CITY OF ALBUQUERQUE

**Re: Dr. Fanning Orthodontics
8130 Ventura St. NE
90-Day Temporary Certificate of Occupancy
Transportation Development Final Inspection
Engineer's/Architect's Stamp dated 7-31-19 (C20D084)
Certification dated 10-28-20**

Re: **Permanent Certificate of Occupancy for
Dr. Fanning Orthodontics
8130 Ventura St NE
Albuquerque, NM 87122**

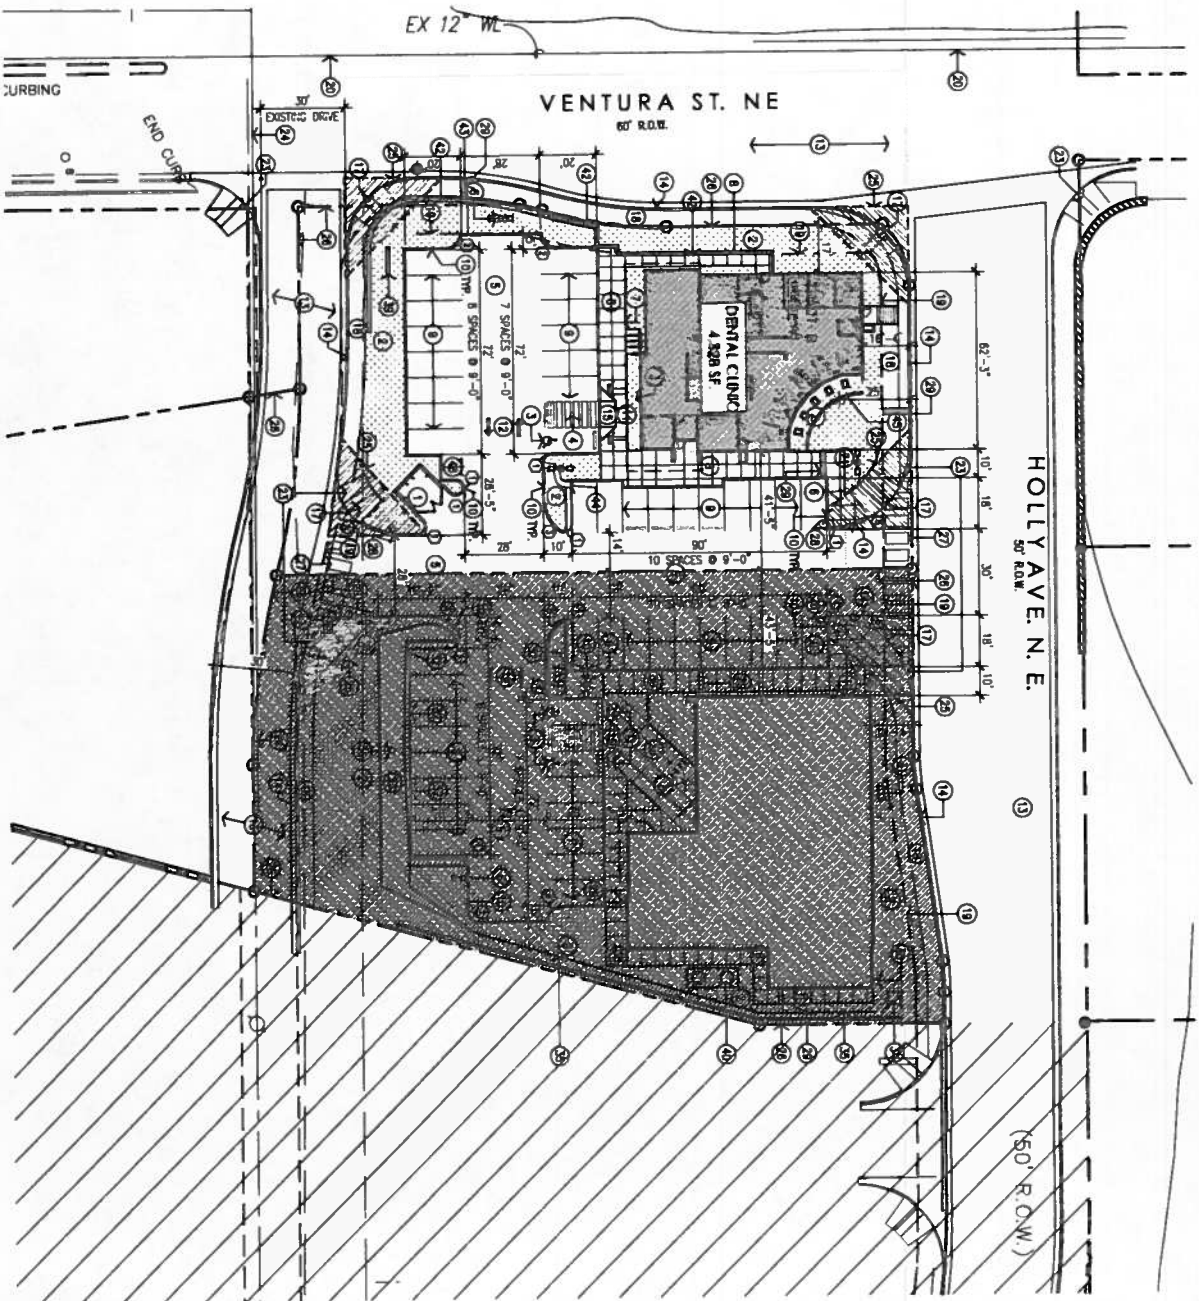
- Prior to release of Final CO a roadway easement is required for future roundabout. Please contact The Traffic Engineer Jeanne Wolfenbarger @ 505-924-3991 or at jwolfenbarger@cabq.gov for questions.

- Given the dramatic slope of the site, it was determined that an accessible sidewalk connection to the public sidewalk would not be possible on the west side of the parking lot. Connection to the public sidewalk is still available at the northeast corner of the property.
- In the approved Architectural Site Plan, four parking spaces were updated to be "compact" to make room for a more generous sidewalk
- The motorcycle parking moved next to the trash enclosure for a more efficient use of space.
